Subject: Oyster Creek Nuclear Generating Station
 Docket No. 50-219
 SEP Topic III-6 Seismic Design Considerations
 (Piping Evaluation)

GPUN letter dated July 1, 1985 transmitted Material Nonconformance Reports (MNCRs), marked-up support and isometric drawings for Control Rod Drive Return, Liquid Poison, Main Steam, Core Spray, Feedwater and Isolation Condenser system piping which were generated during our IE Bulletin 79-14 re-inspection effort. These six piping systems were reviewed under the Systematic Evaluation Program (SEP).

At a recent request of your staff, we are transmitting the MNCRs and marked-up drawings to you and Mr. M. Nitzel of EG&G, Idaho.

OYSTER CREEK
CORE SPRAY SYSTEM
MNCR'S
(INSIDE CONTAINMENT)

SCALE: NONE	APPROVED BY: [Signature]	DRAWN BY: JWH
DATE: 10-4-72	DISCHARGE PIPING HANGER FOR 5" ELECTRO-MATIC RELIEF VALVE	
DRAWING NUMBER: 1083-14-27		RE:

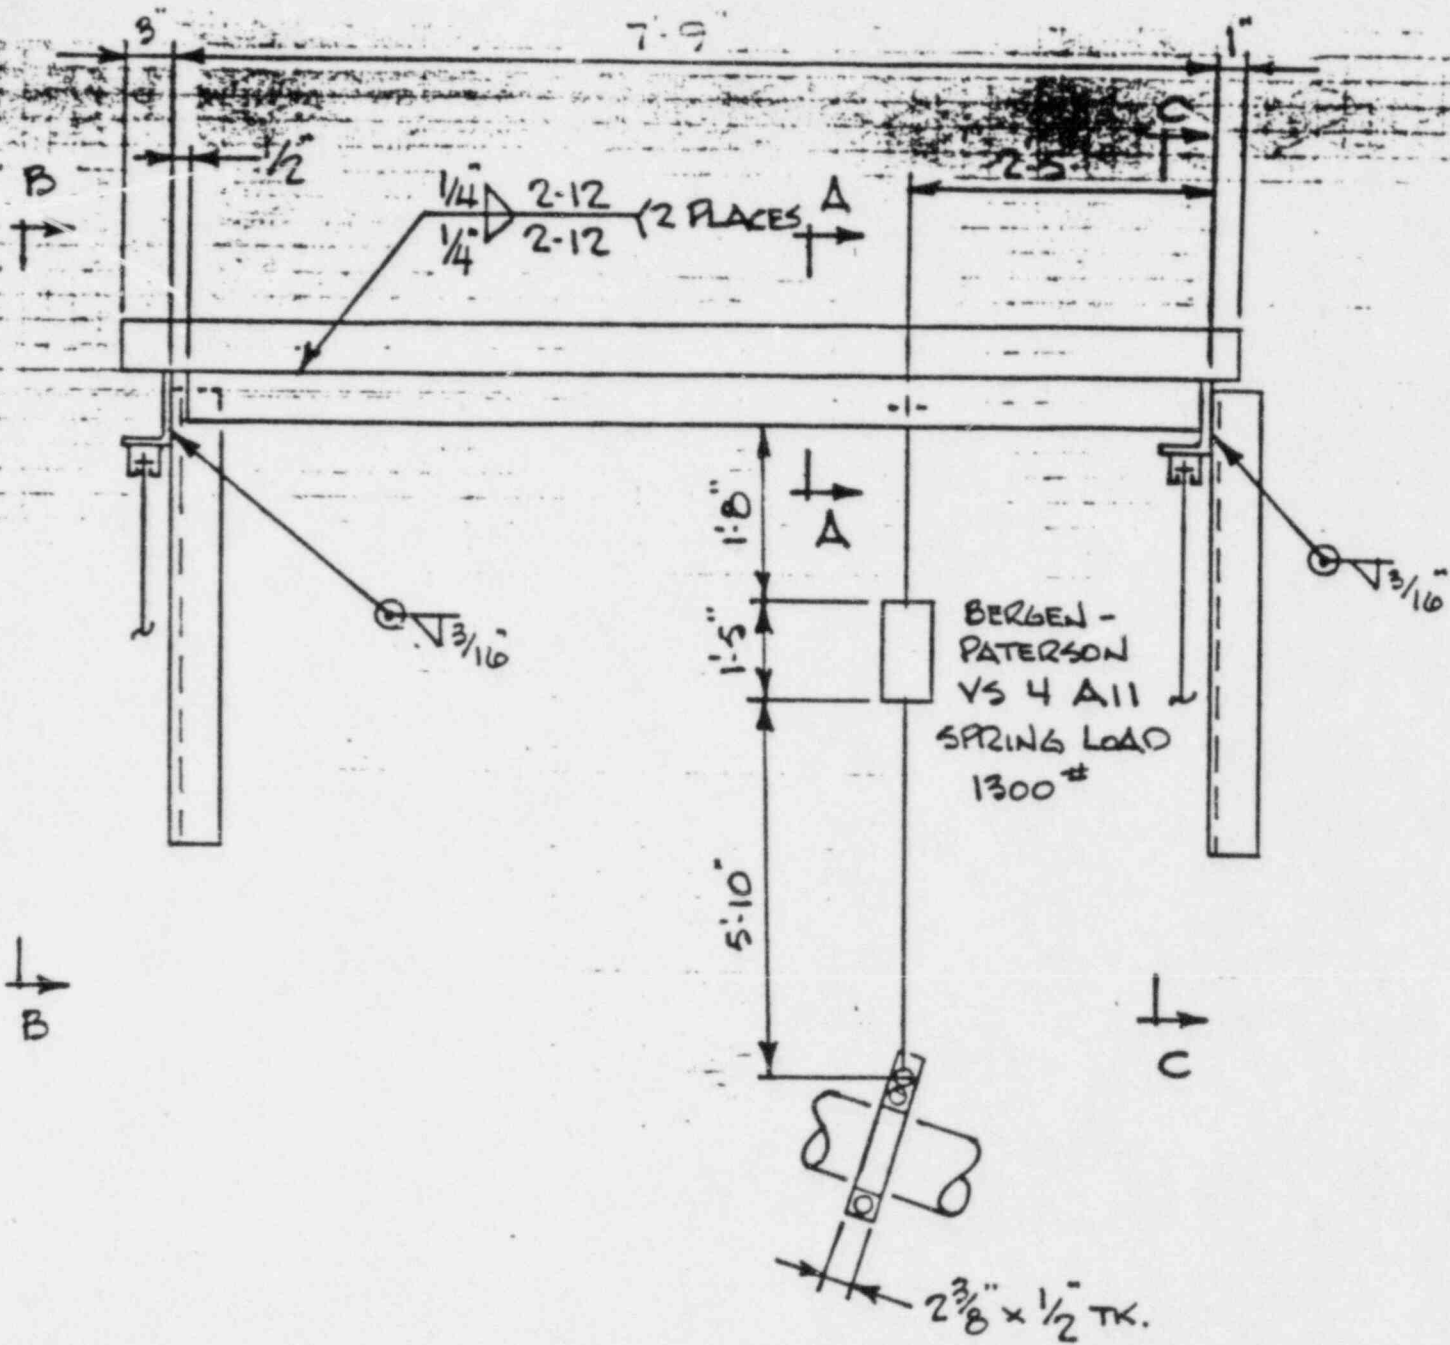
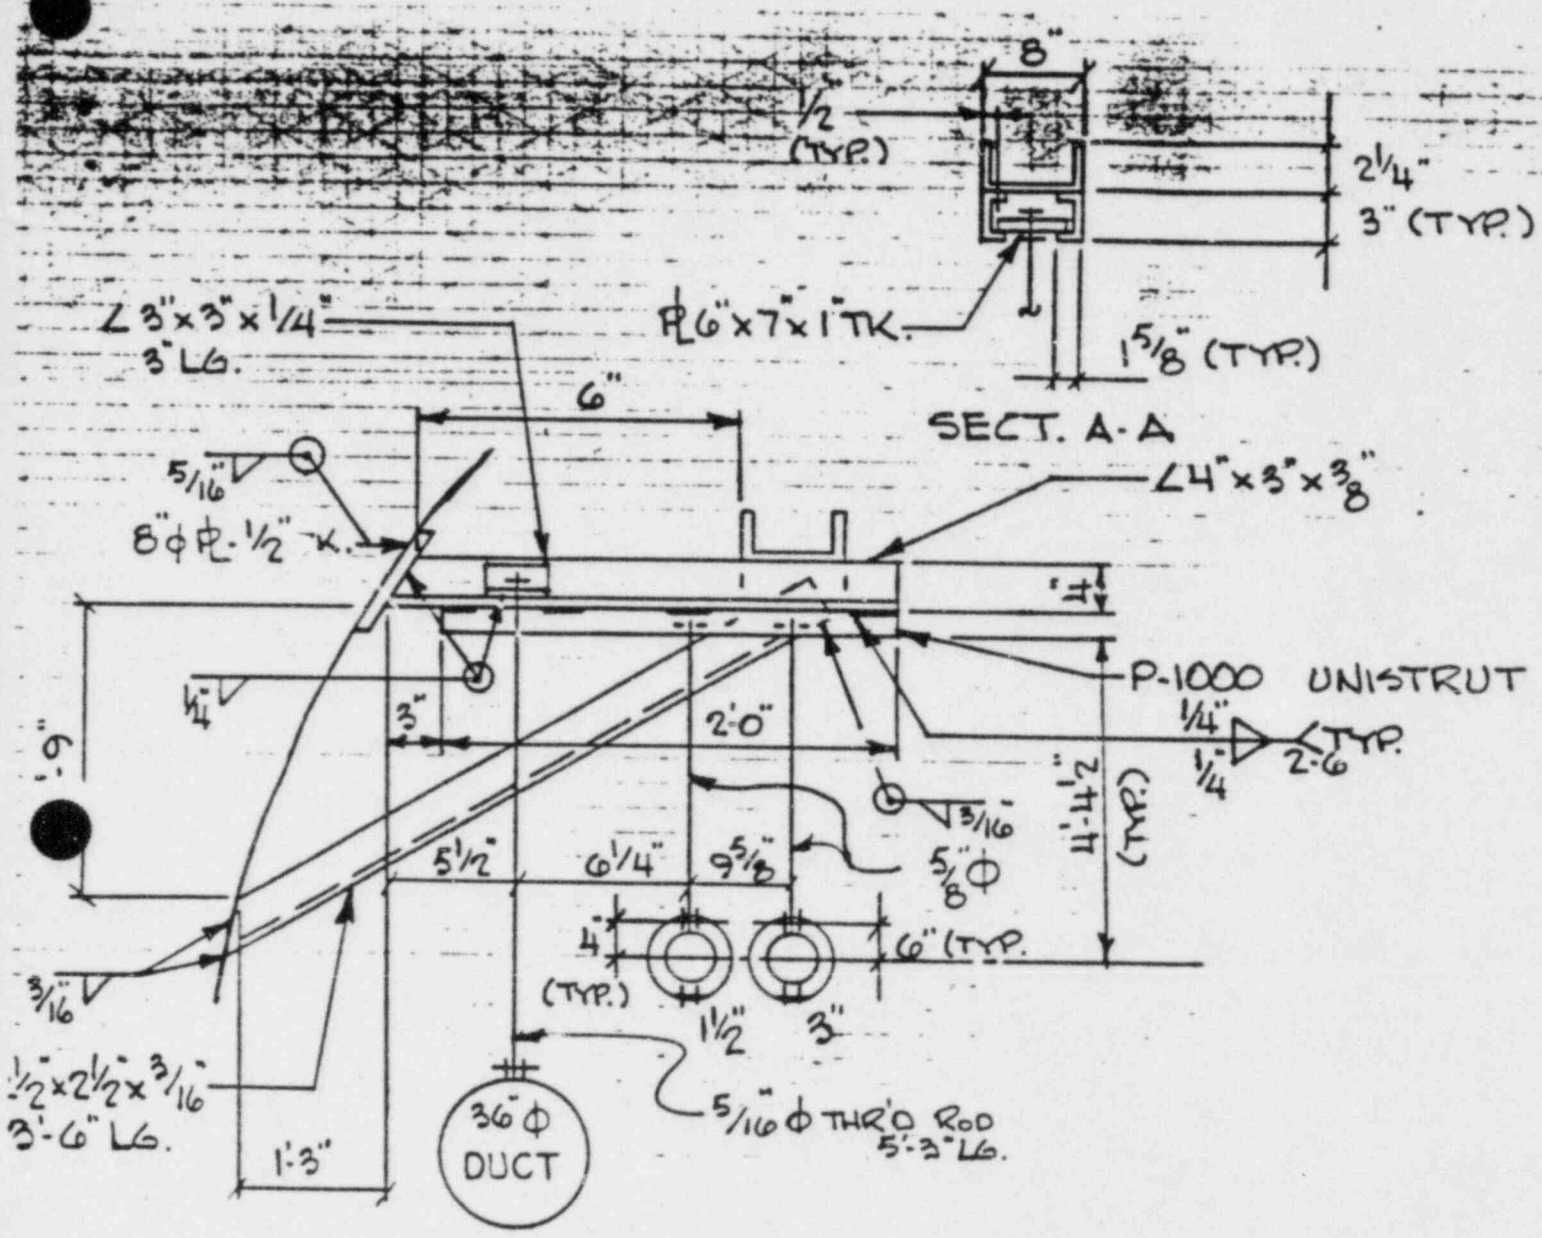
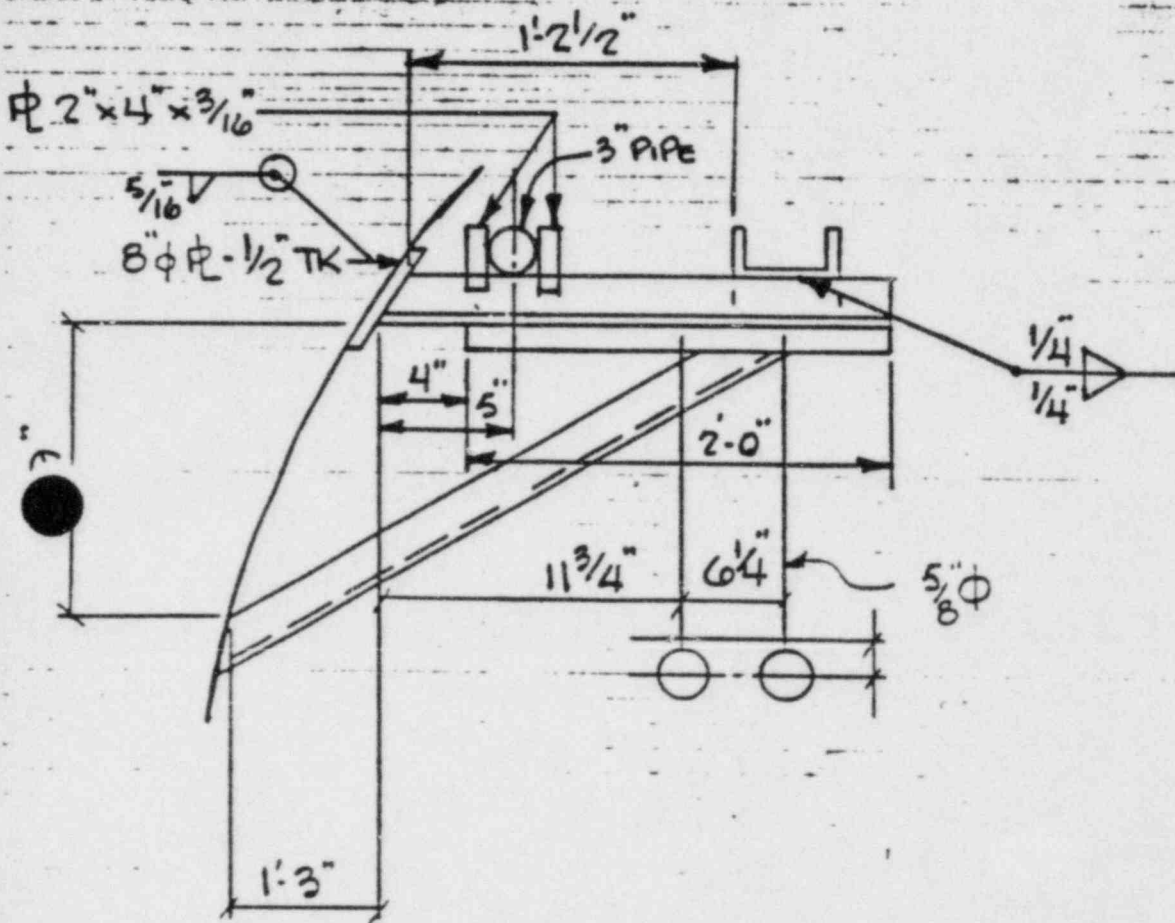
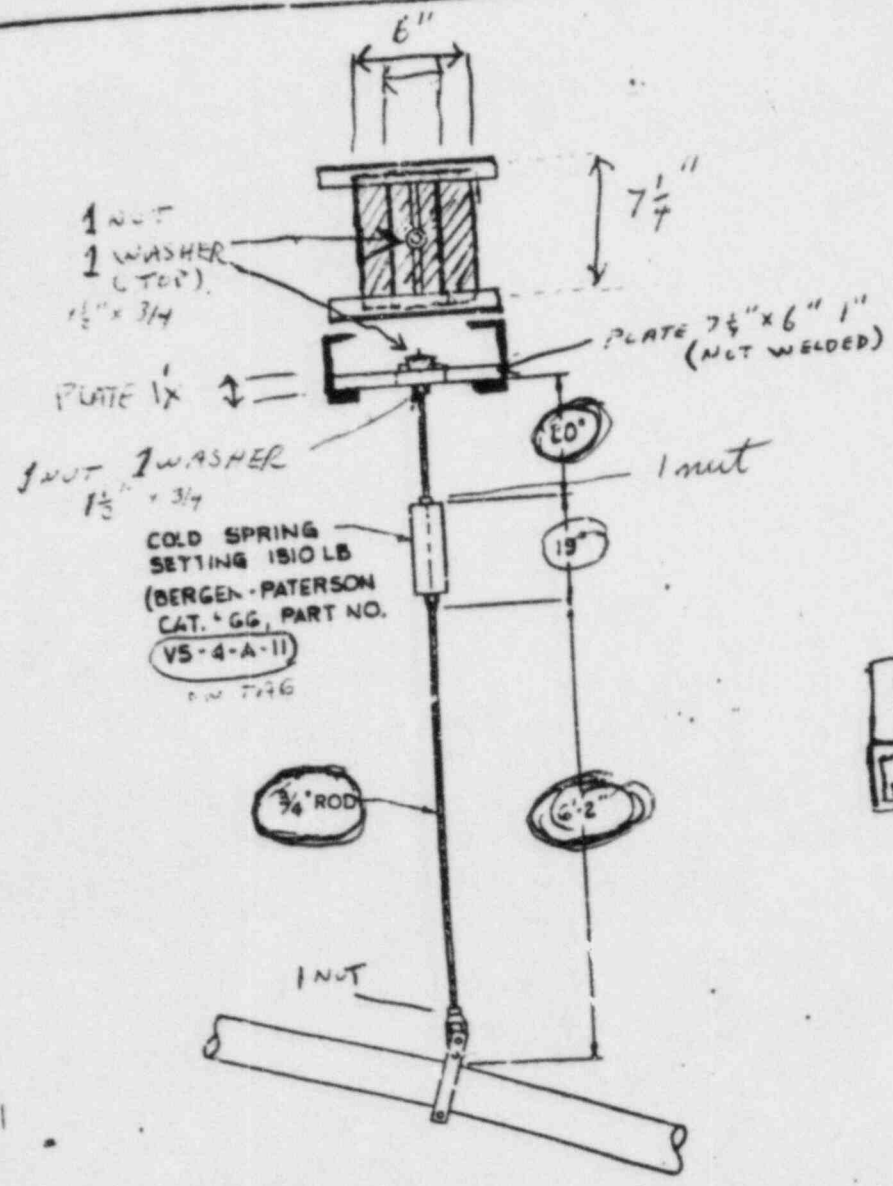
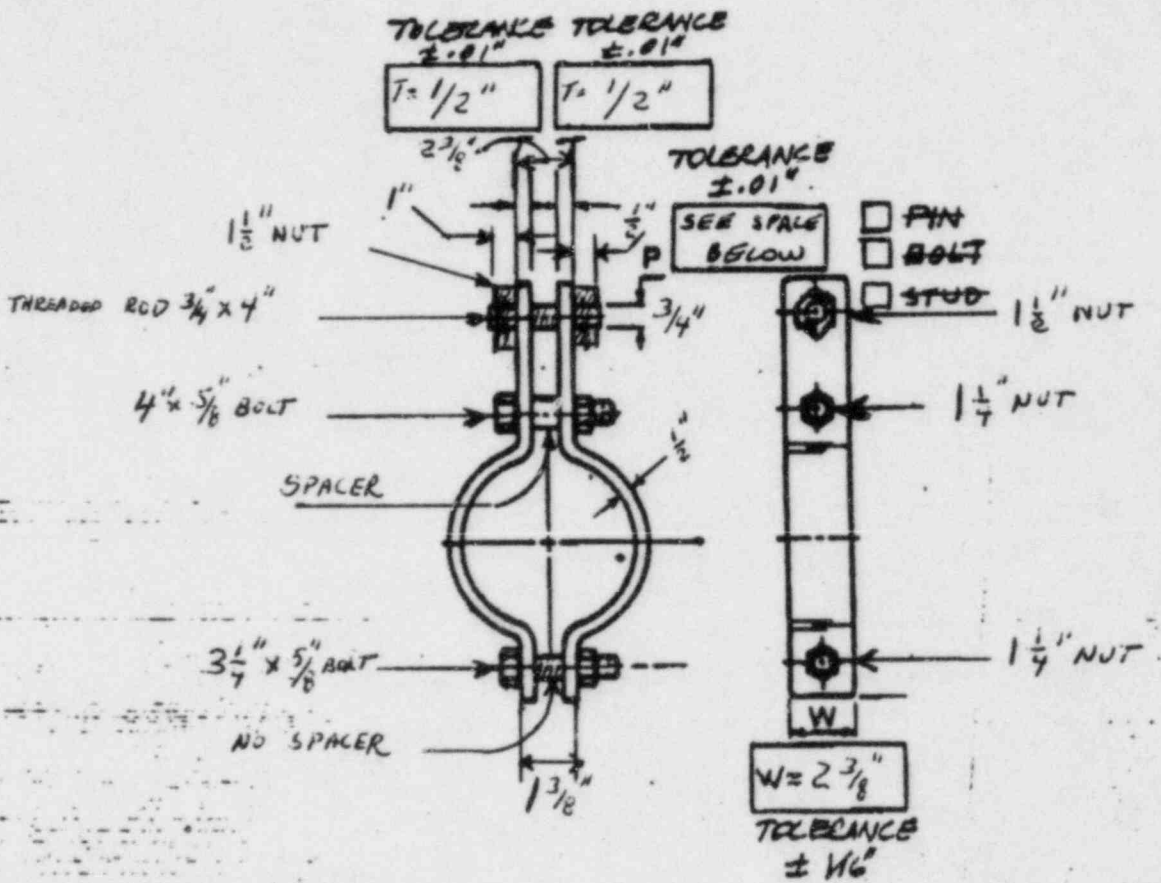
PLEASE PROVIDE DIMENSIONAL & CONFIGURATION
INFO. REGARDING MAIN STEAM (EMRV)
HANGER VS-4-A-11 AS SHOWN ON MPR
DWG. 1083-14-27.
